### Public Comments on the Draft GSP on Dec 11 2021

**Re: Public Comment Letter for Turlock Subbasin Draft GSP**

## Specific Comments on the Turlock Subbasin Draft Groundwater Sustainability Plan

**Re: Comments on the Turlock Subbasin Groundwater Sustainability Plan (GSP).**

**Figure 1.** Groundwater elevation representative monitoring sites in relation to key beneficial users: a) Groundwater Dependent Ecosystems (GDEs), b) Drinking Water users, c) Disadvantaged Communities (DACs), and d) Tribes.

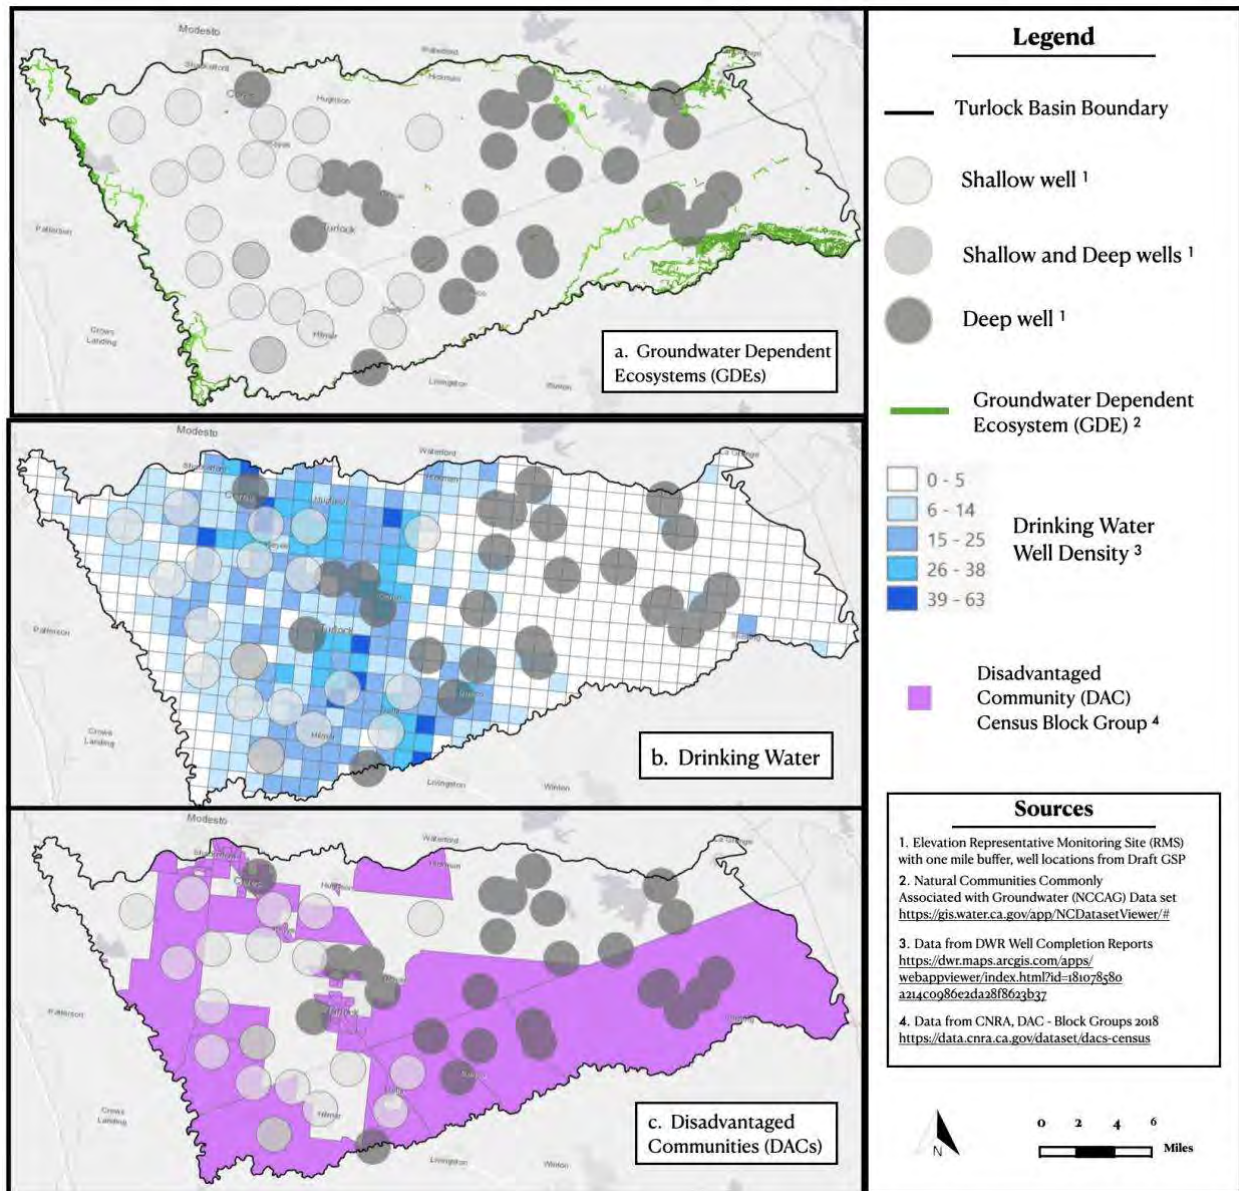
Figure 7-4 (Water Quality Monitoring Sites) shows sufficient representation of DACs and drinking water users for the water quality monitoring network. Maps of shallow and deep wells within the subbasin (Figures 7-1 to 7-3) show insufficient spatial representation of DACs and drinking water users for the groundwater elevations monitoring network, particularly in areas with the highest density of drinking water wells. Refer to Attachment E for maps of these monitoring sites in relation to key beneficial users of groundwater. Note that we were only able to map groundwater elevation RMSs with information provided in the Draft GSP.

- Provide maps that overlay current and proposed monitoring well locations with the locations of DACs, domestic wells, and GDEs to clearly identify monitored areas.
- Increase the number of RMSs in the shallow aquifer across the subbasin as needed to map ISWs and adequately monitor all groundwater condition indicators across the subbasin and at appropriate depths for *all* beneficial users. Prioritize proximity to DACs, domestic wells, GDEs, and ISWs when identifying new RMSs.
- Ensure groundwater elevation and water quality RMSs are monitoring groundwater conditions spatially and at the correct depth for *all* beneficial users - especially DACs, domestic wells, and GDEs.
- Describe biological monitoring that can be used to assess the potential for significant and unreasonable impacts to GDEs or ISWs due to groundwater conditions in the subbasin.

**Figure 3 - Impact on Domestic Wells at MT Water Levels**  
West and East Turlock Subbasin GSA

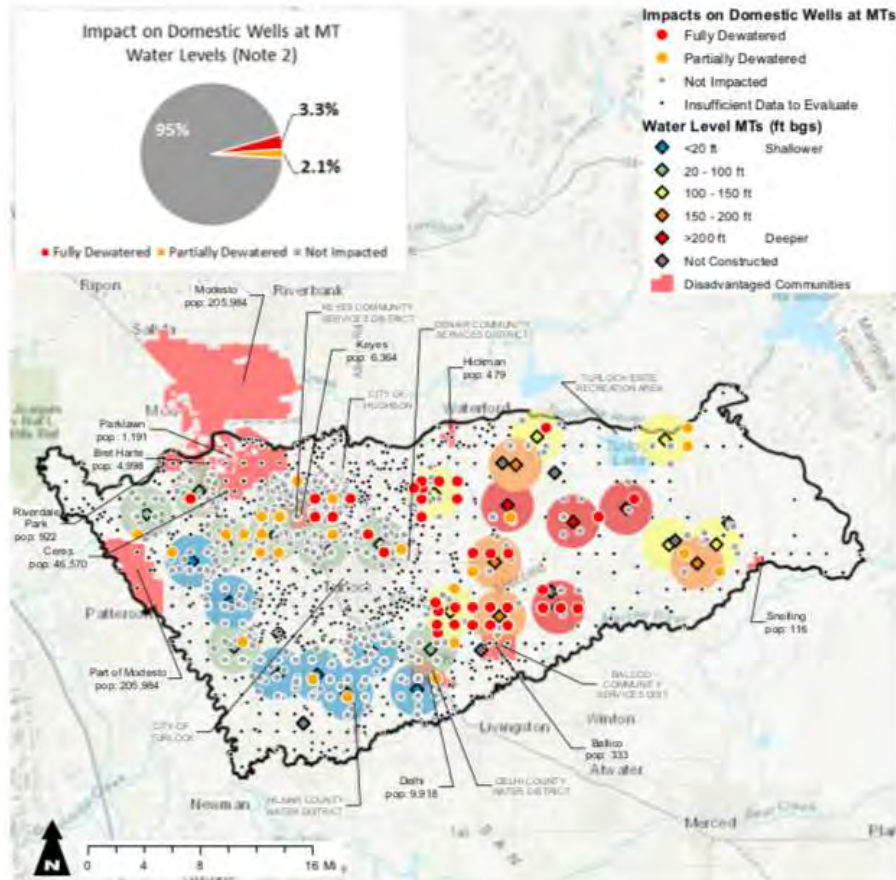
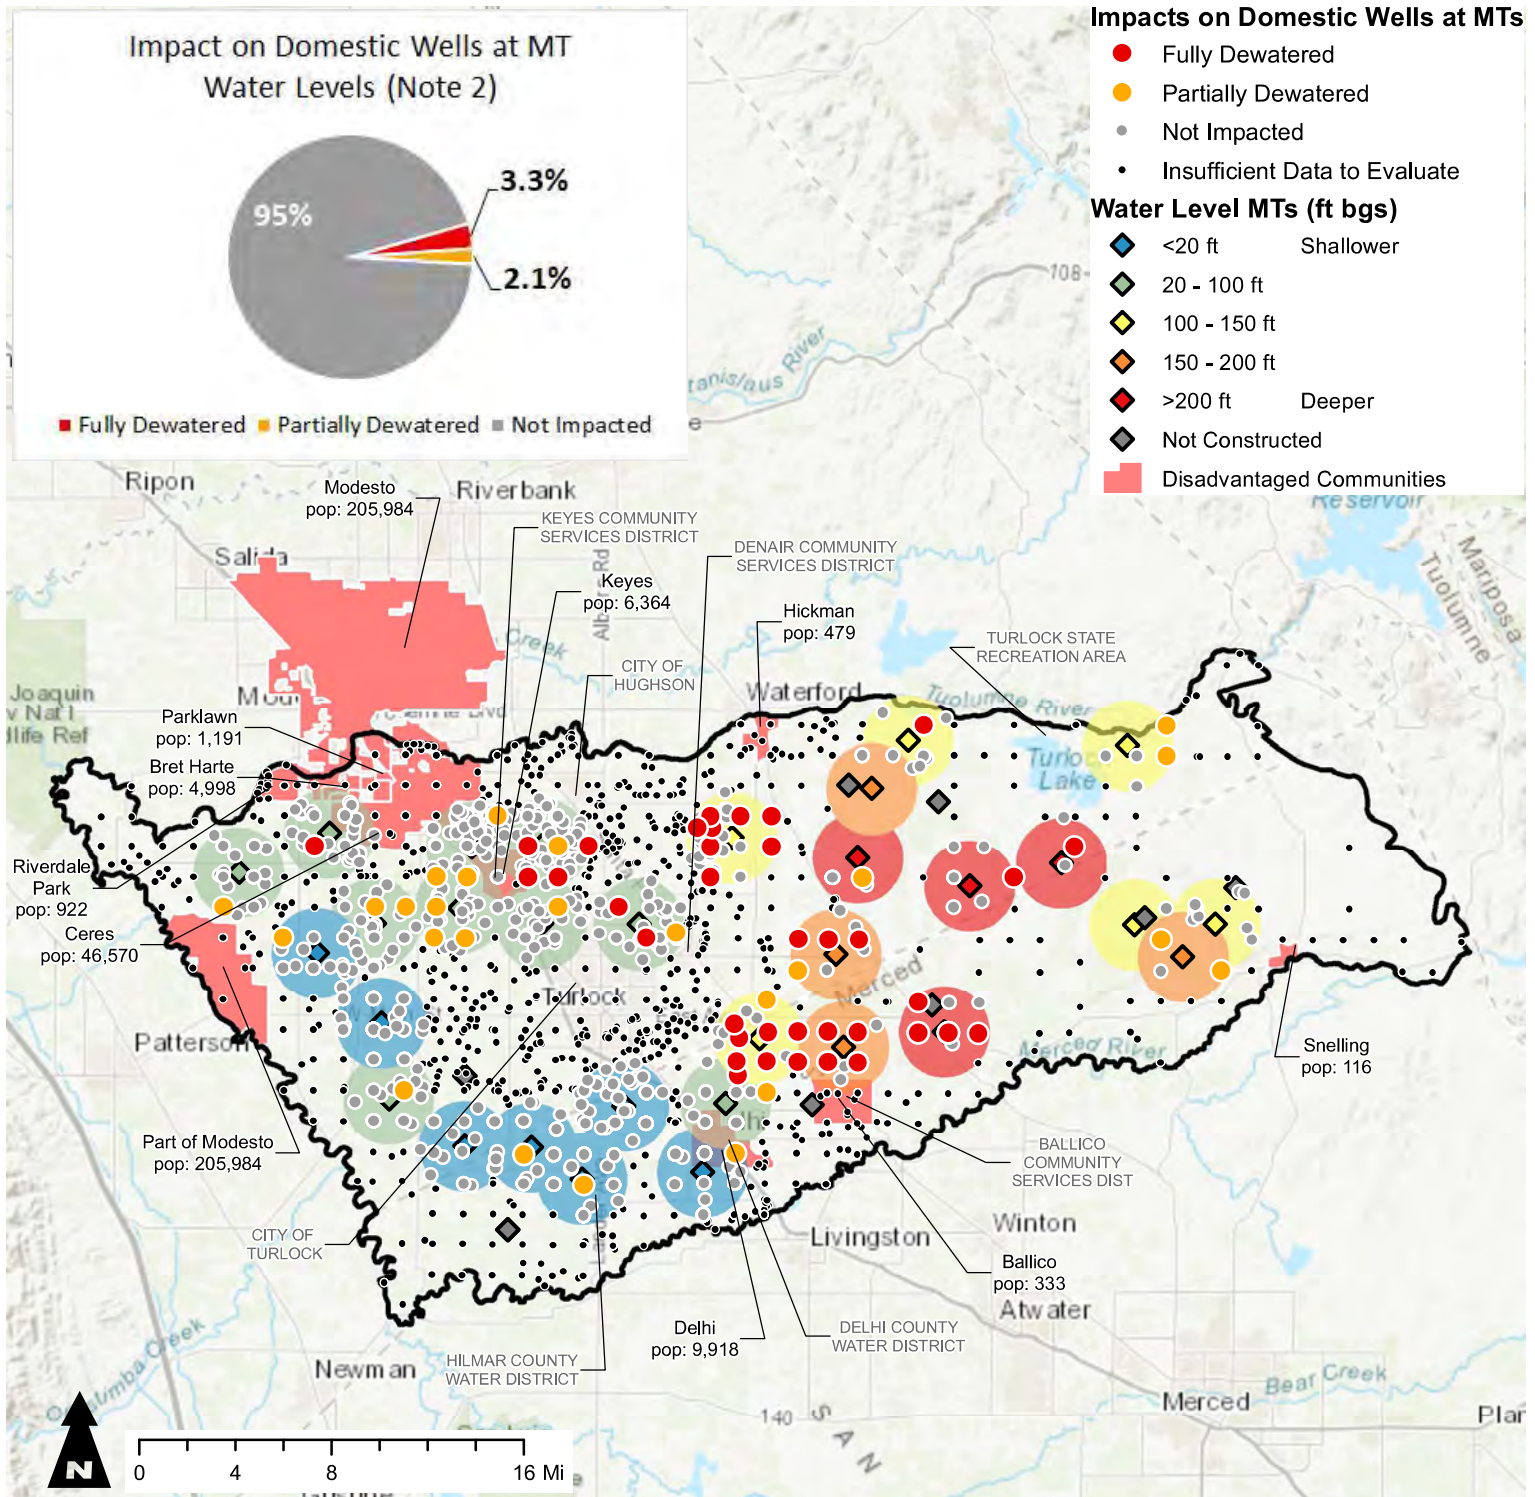
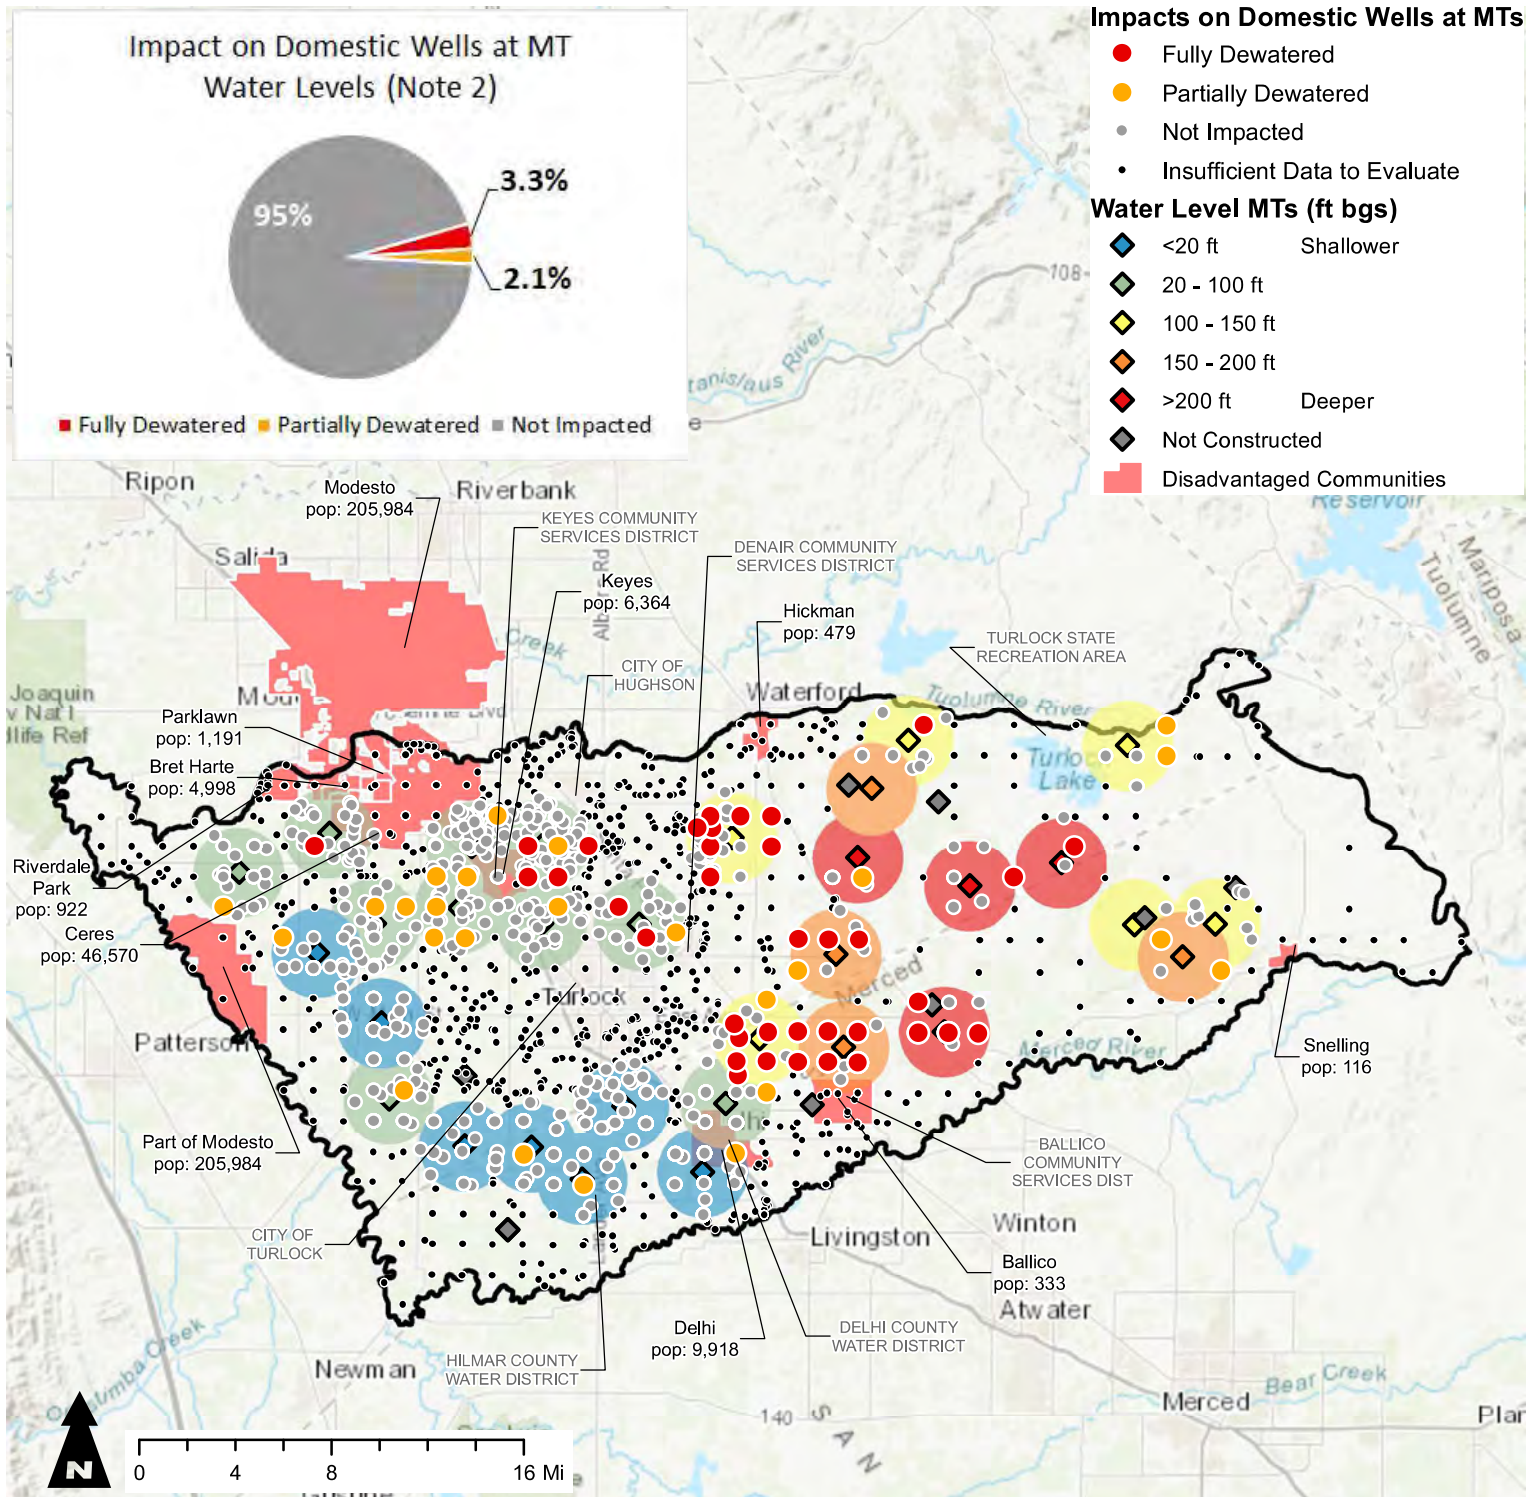
allows for water levels in significant portions of the Subbasin to continue to drop below minimum thresholds, additional domestic well users would be vulnerable to impacts. Further, more than half of domestic wells are located outside of the area analyzed by the Focused Technical Review, and may also be impacted by declining water levels.

Therefore the GSP should present a thorough, robust, and transparent analysis, supported by maps and accurate and comprehensive data, that identifies: 1) which domestic wells are likely to be impacted at the minimum thresholds, 2) which domestic wells are likely to be impacted as water levels are allowed to drop below minimum thresholds before the undesirable results definition is met, 3) the location of the likely impacted wells with respect to DACs and other communities and systems dependent on groundwater, and 4) an estimate of the total population likely to be affected, and 5) whether domestic well impacts have a disparate impact on protected classes under civil rights law. This assessment should include multiple scenarios in which 33% or more RWMs exceed their minimum thresholds for three years, to appropriately represent conditions that may occur under the GSAs' definition of undesirable results. This analysis would allow the GSAs not only to evaluate the potential impacts, but to proactively prevent, or, if

- **Figure 3** shows the approximate locations of domestic wells and water level RMWs (excluding those identified as being in the Western Lower principal aquifer) within the Subbasin. For purposes of this evaluation, a 1.5-mile radius is shown around each RMW. Based on available well construction information, the well screens of the domestic wells located within this 1.5-mile radius are compared to the proposed MTs for the RMWs. For purposes of this assessment, a well is identified as fully dewatered if the MT is below the midpoint of the screen well screen interval, and partially dewatered if the MT is below the top of the screen interval. For domestic wells with incomplete well screen information, it is assumed that the well screen extends 40 feet above the bottom of the well. Approximately 43% of domestic wells in the Subbasin are located within the 1.5-mile radius of RMWs; given the location of the RMWs this analysis excludes the approximately 2,500 domestic wells, including those located in and around the communities of Hughson, Ceres, Hickman, Bret Harte, Parklawn, southern Modesto, Ballico, Delhi, Snelling, and Turlock (most of which are DACs). Based on this assessment, if water levels reach the proposed MTs, approximately 3% of domestic wells within a 1.5-mile radius of RMWs (approximately 61) would be expected to be fully dewatered and an additional 2% of domestic wells within a 1.5-mile radius of RMWs (approximately 38) would be expected to be partially dewatered.
